# Access Compliance Report

## Public Rights-of-Way

Intersection ID: 50464	Main Street: LENOX_POINTE_DR	Cross Street: SANDY_PORTER_RD	Location: W
ADA ID: DEA80EEC519A	Ramp Type: Perp	Initial Pass/Fail: Fail	Overall Compliance: No
Severity Score: 1.25			
Codes/Mitigation Info/Possible Solution		Field Measurements/Component Compliance

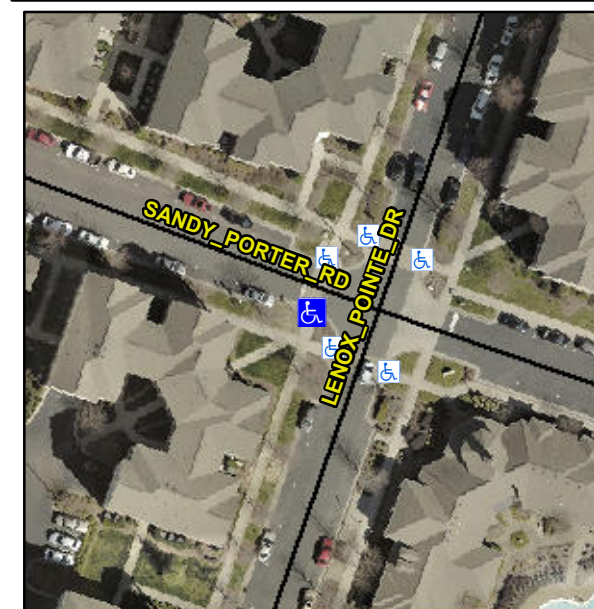
**Remove & Replace Entire Ramp.**

**Not Found, R304.5.3**

Compliance	Description	Data	Compliance	Description	Data
N/A	Ramp Length (in)	71.5	Yes	Ramp Slope (%)	6.3
Yes	Ramp Width (in)	48.0	No	Ramp XSlope (%)	3.5
N/A	Flare Type LT	N/A	N/A	Flare Type RT	N/A
N/A	Flare Slope LT (%)	N/A	N/A	Flare Slope RT (%)	N/A
N/A	Flare Traversable LT?	N/A	N/A	Flare Traversable RT?	N/A
N/A	Landing Length (in)	N/A	N/A	DWS Provided?	N/A
N/A	Landing Width (in)	N/A	N/A	DWS Contrast?	N/A
N/A	Landing Slope (%)	N/A	N/A	DWS Length (in)	N/A
N/A	Landing X Slope (%)	N/A	N/A	DWS Full Width?	N/A
N/A	Landing Curb? (Y/N)	N/A	N/A	DWS Offset (in)	N/A
N/A	Shared Landing?	N/A			
N/A	Gutter Ponding?	N/A	N/A	Gutter Slope (%)	N/A
N/A	Gutter Lip Ht (in)	N/A	N/A	Gutter X Slope (%)	N/A
N/A	Painted X Walk1?	Yes	N/A	Painted X Walk2?	N/A
	X Walk 1 Direction	To NE		X Walk 2 Direction	N/A
N/A	X Walk 1 Width (in)	144.0	N/A	X Walk 2 Width (in)	N/A
	X Walk 1 Slope (%)	7.4		X Walk 2 Slope (%)	N/A
	X Walk 1 X Slope (%)	4.2		X Walk 2 X Slope (%)	N/A
